CARMACKS COPPER PROJECT

**INITIAL ENVIRONMENTAL EVALUATION
ADDENDUM**

June, 1995

KNIGHT PIESOLD LIMITED CONSULTING ENGINEERS - VANCOUVER, B.C.		WESTERN COPPER HOLDINGS LIMITED CARMACKS COPPER PROJECT	
*	DESIGNED	BB	LEACH FACILITY SECTION AND DETAILS SHEET 1 OF 3 FIGURE 1.5
	DRAWN	NSD	
	CHECKED	*	
	APPROVED	*	
DATE		MAY 1, 1995	SCALE AS SHOWN
DRG. NO.		1783.220	REV. 0

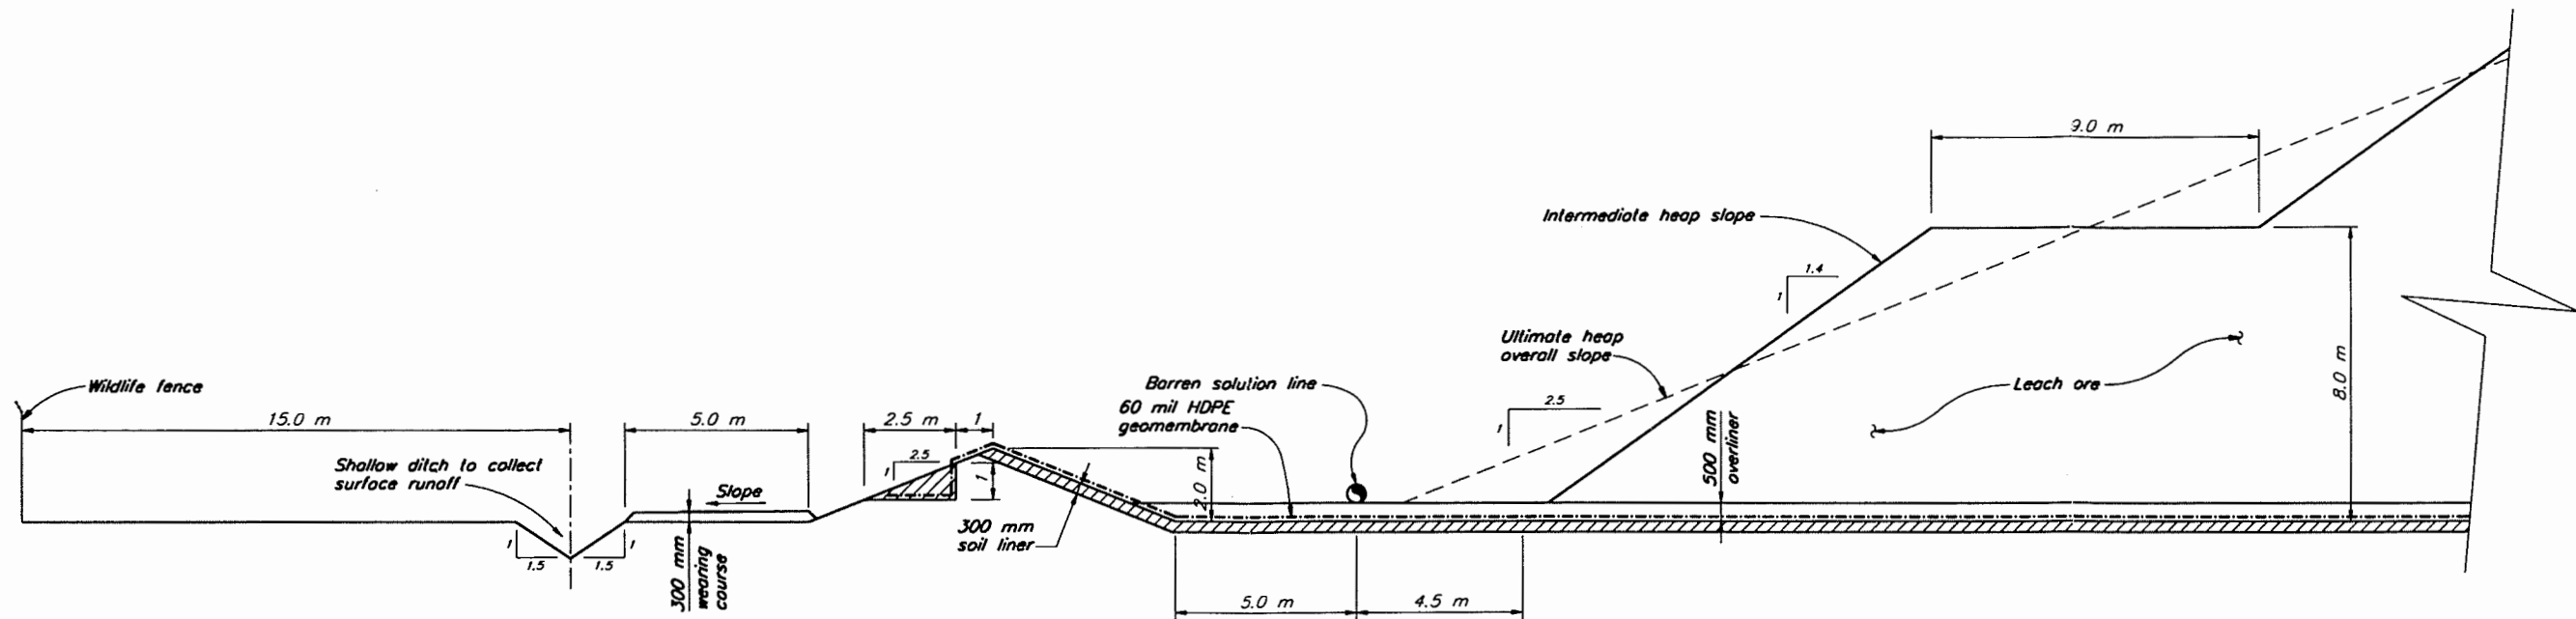
- *p. 8-6*, "...protective cover layer of crushed ore... over the liner... differs from other statements... and from design indicated in drawing 400-35-F04(b)... Can the proponent clarify this

Modifications to heap leach design, including liner type, are presented in the Knight Piesold Ltd. report (1995). Details on liner system design are presented in Section 4.6 and a cross section of the pad is presented in Drawing 1783.220.
